We thank 2 anonymous reviewers for the precise and helpful comments about our manuscript. We realize that a lot of time went into the reviewing process, giving the precise (and justified) remarks. We answered each of the comments, and modified the text and the figures accordingly. The revised version of the manuscript is much clearer, some mistakes were corrected, some new references were added, and some more links to CMEMS products were given, all according to the reviewer's comments.

#### Reviewer 1

## Reviewer 2

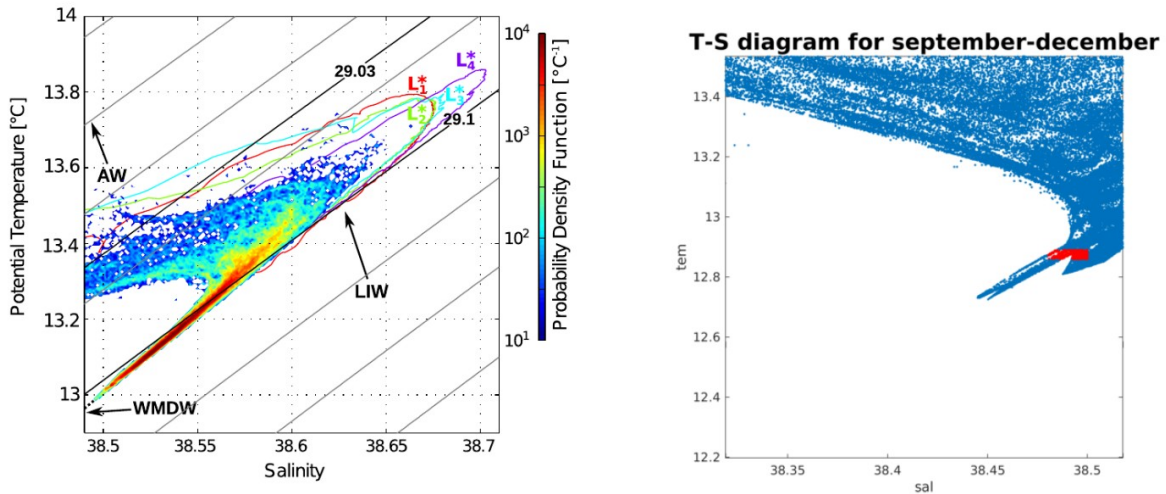
Line 15: What do you mean bay “depth is larger than 1000m”? Is it the depth reached by deep convection? Maybe you want to put it at the end of the first phrase at line 13. Here you are describing the WMDW characteristics.

Line 17: Which tail? How could the river see that? Please explain or describe with some detail.\n
 Bosse et al (2015) show the T-S diagram and indicated the water masses (left plot below). We reproduce this plot from model results (right plot below) and obtain a longer tail (it goes to  $\sim 12.7^\circ\text{C}$  and slightly lower than 38.45 psu). The definition from Bosse et al (2015) would result only in the red rectangle in the right plot below. Therefore we slightly adapt the WMDW definition in order to capture the whole tail. We decided not to include these 2 figures in order to keep the paper more concise.

Following Bosse at al (2015), we consider that water is WMDW if it is within a certain T and S range, AND if it is situated below 1000m depth

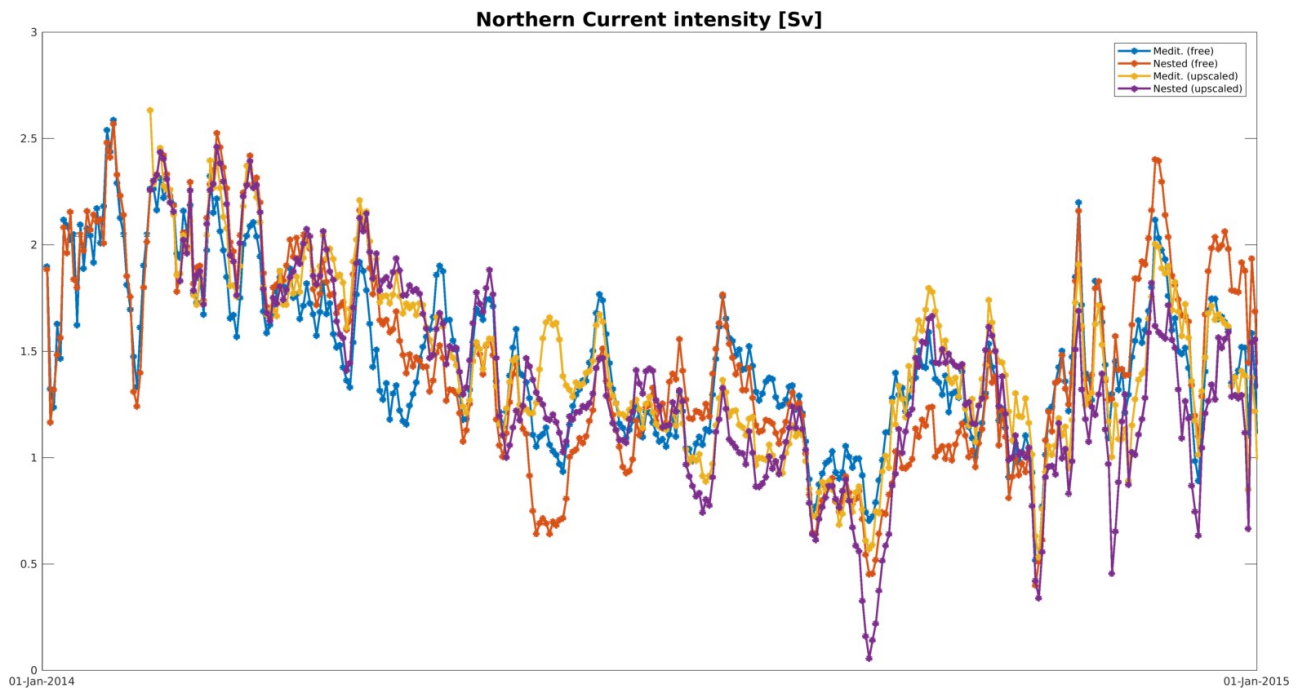
Figure 7: Please insert NW-Med and the legend.

[Once upscaling modifies the parent model, the child model gets different open-sea boundary conditions from the parent, and starts to be different as well. Thus, for Figures 6 and 7, we could add 2 NW-Med curves to the figures \(one corresponding to the free run and one corresponding to the upscaling run\).](#)

[For the Northern Current intensity, it gives this :](#)

This figure becomes difficult to interpret. There is no general trend, like for example a systematically more intense Northern Current in nested models. However, what's interesting is that generally speaking, compared to the free Med model (blue curve), the yellow curve seems to get closer to the purple (child model of the upscaled Med model). The discrepancy between yellow and purple is smaller than the discrepancy between blue and red. This can be verified by looking at RMSD errors between parent and child model in the two cases (free model or upscaled model), respectively 0.22 and 0.19 Sv. The RMSD for all metrics have now been included in a table as suggested by the reviewer.
